Subject: Cefn solar farm - NMA revised drainage scheme
Ref: Addendum to FRA & SWMP (735 SP03)

This is an Addendum to the Flood Consequences Assessment (FCA) and Surface Water Management Plan (SWMP) previously submitted for the proposed solar farm at Cefn Park. The Addendum is required to address the potential impact of changes made to the layout.

Figure 3: Isolated Infrastructure Components (Revised Figure 3-1 from SWMP)

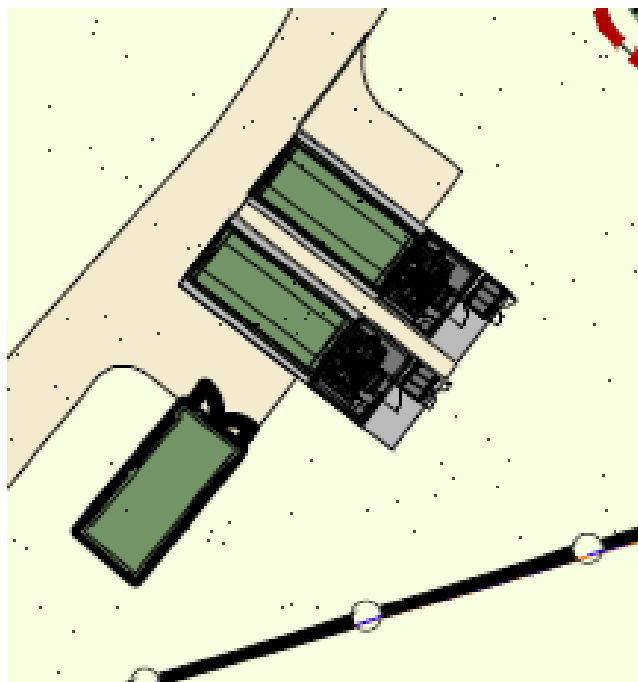
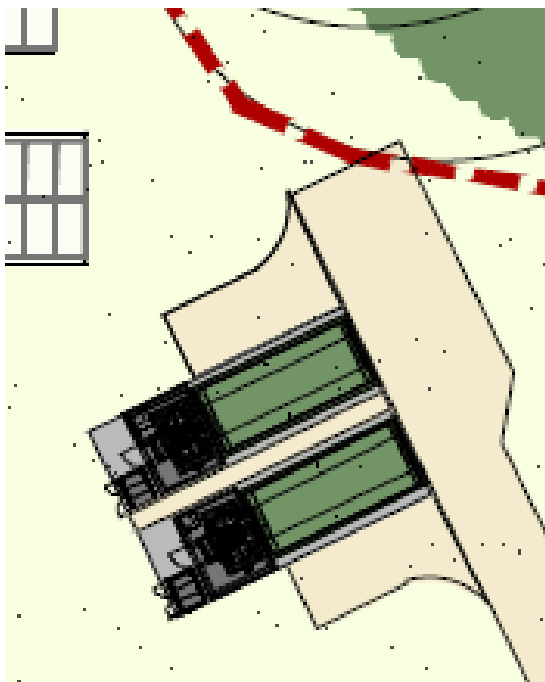
- Removal of the BESS (Battery and Energy Storage System) with solar panels in its place;
- Removal of the soil bunds around the inverters as shown in Figure 3.

The removal of the BESS constitutes the removal of impermeable surfaces from the development. Runoff from the BESS was to be attenuated in the gravelled areas around the BESS, but this facility is no longer required.

It is proposed that the area previously occupied by the BESS be used to extend the solar panels. This does not require any additional mitigation given the principle that the panels do not in themselves lead to any increase in runoff.

The proposed changes do not require any change to the SuDS as originally proposed.
